**MUNICIPAL CORPORATION
KARACHI.**

Re: Plot No. 103. M.M.6.

AMENDED
PLAN SHOWING PROPOSED ADDITIONS & ALTERATIONS ON PLOT N: 103. SHEET N: M.M.6.
MACHIT MIANEE QUARTER
Scale 8 1/2" = 1" = 10' INCH

With reference to your application dated 13th February 1939 with a plan for the proposed buildings/additions and alterations on plot No. 103 Survey Sheet No. M.M.6, Machi Meani Quarter, I have to request you to comply with the following requirements:—

APPROVED:
 NOV 3 - 1938
 Land Manager and Architect
 NARINDAS M. GIDYANI & CO.

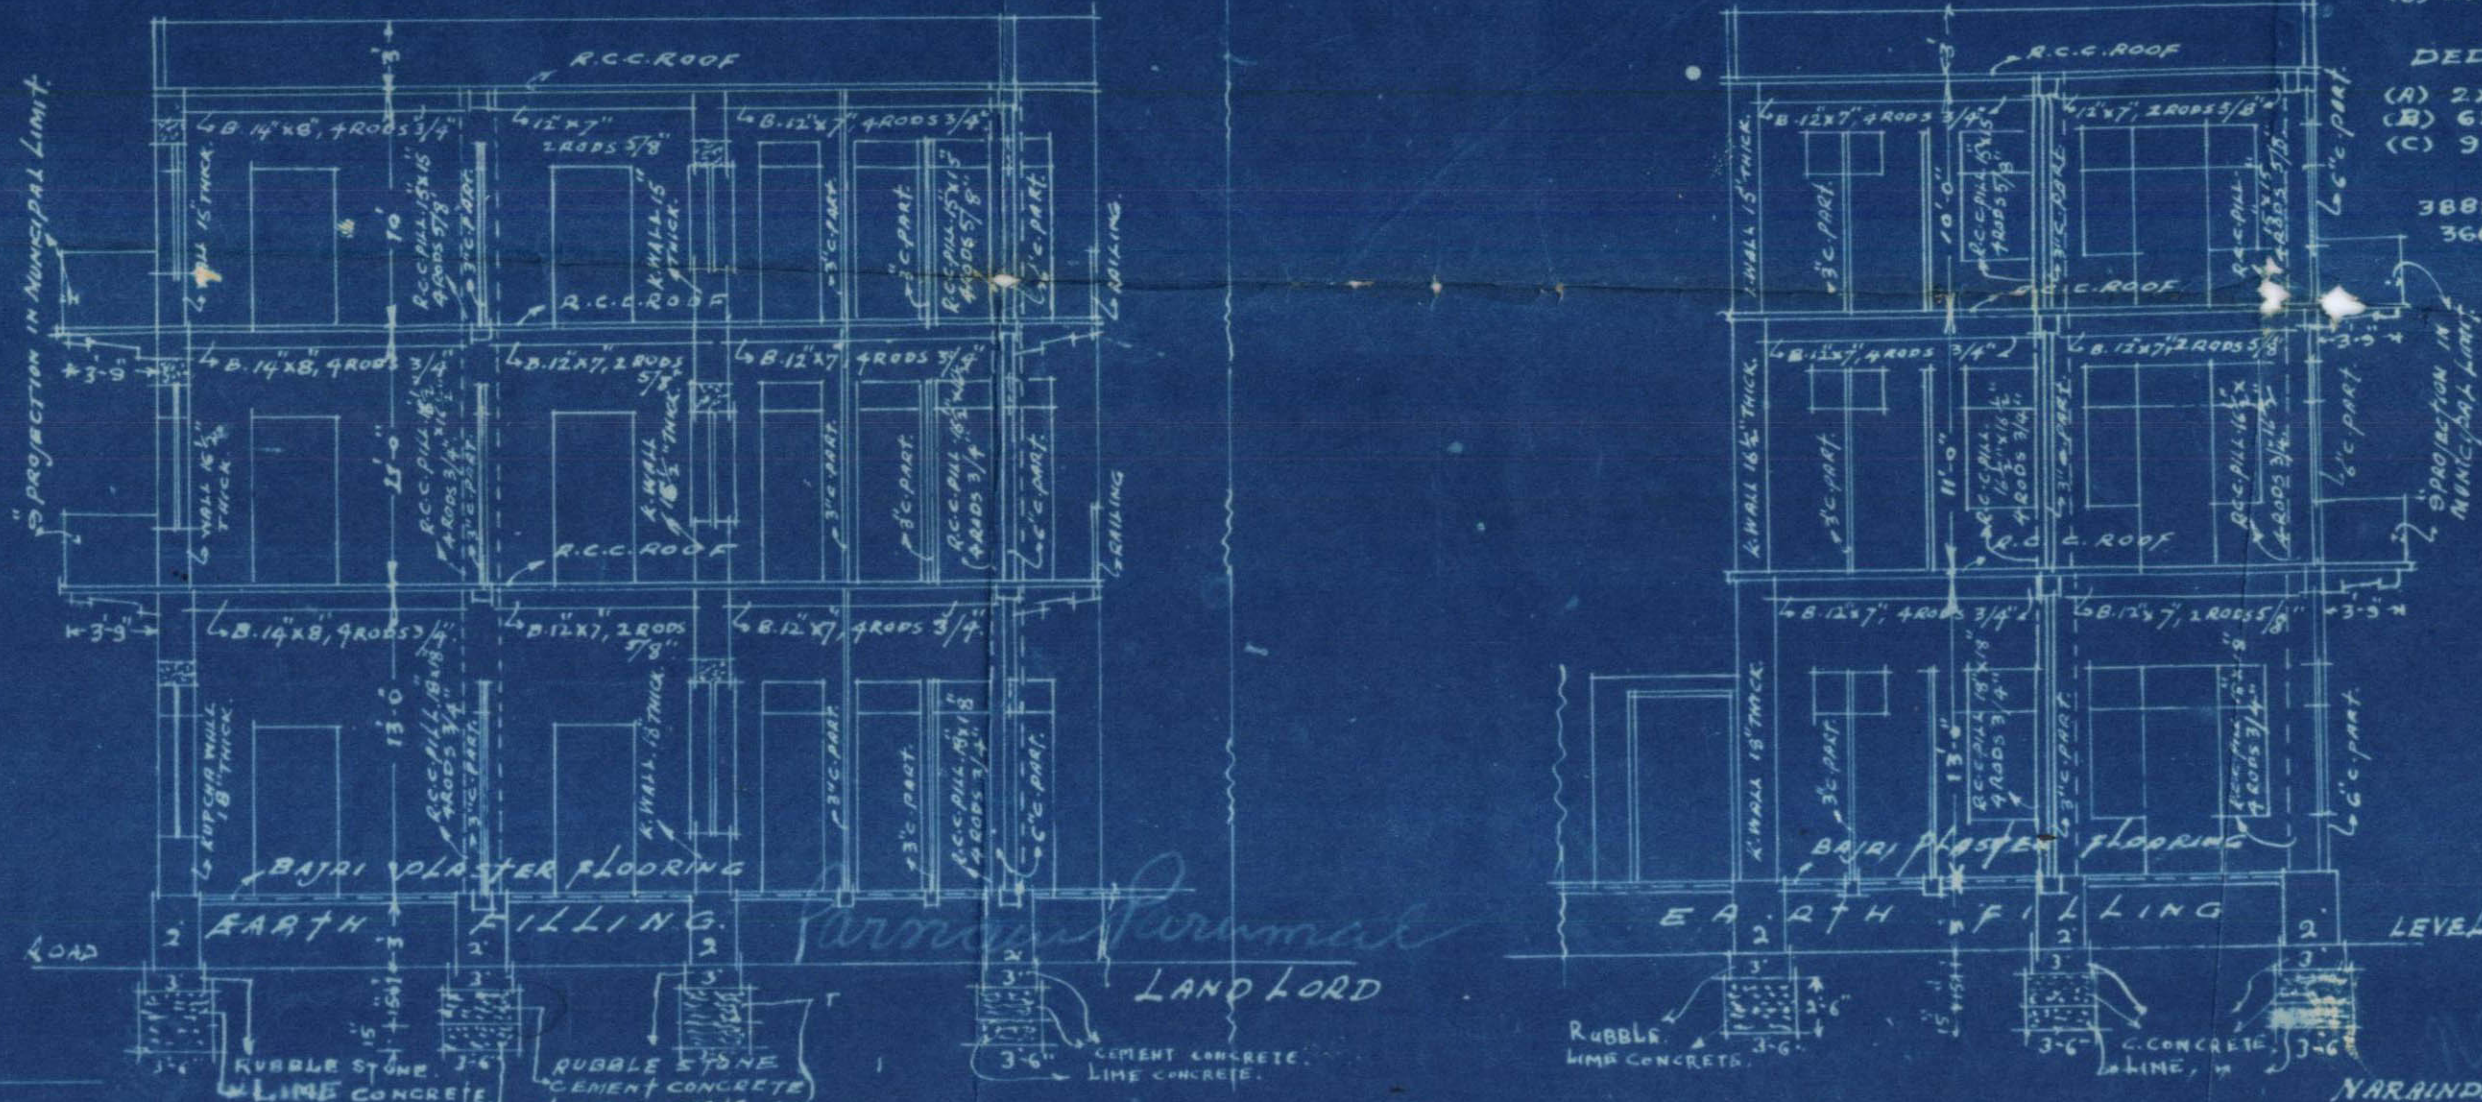
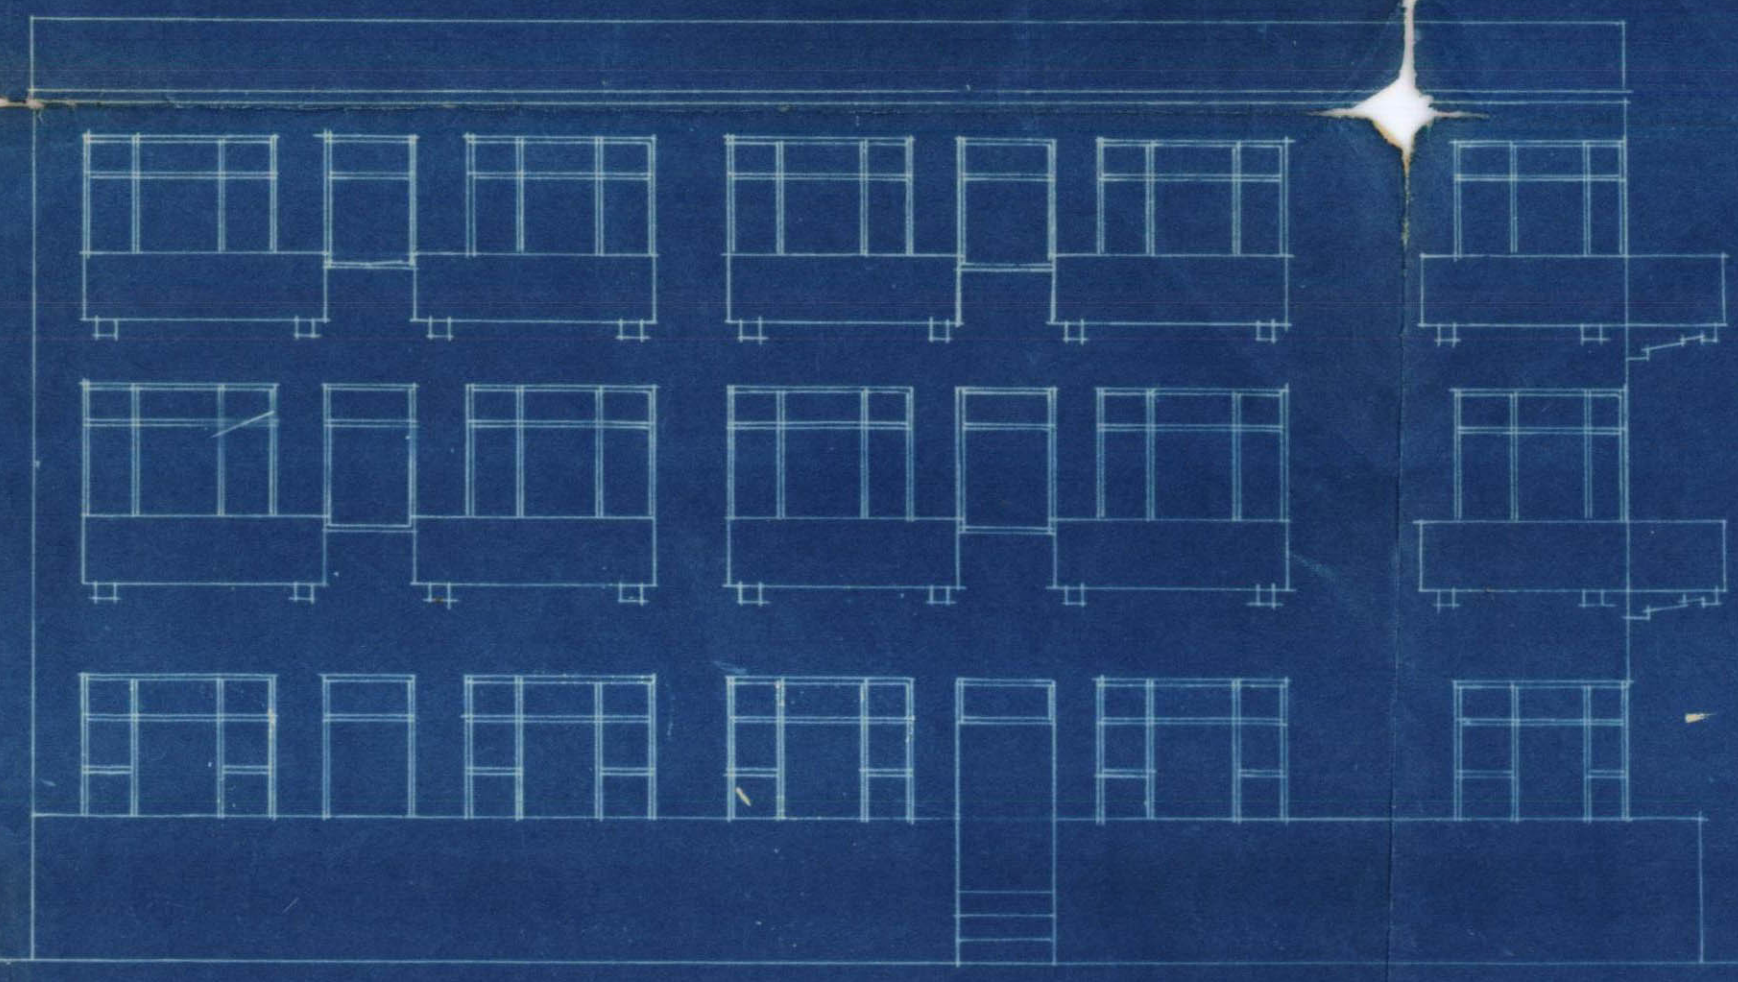
NOTE:-
 Plan approved subject to
 confining the built up area
 to 2/3 only of net area.
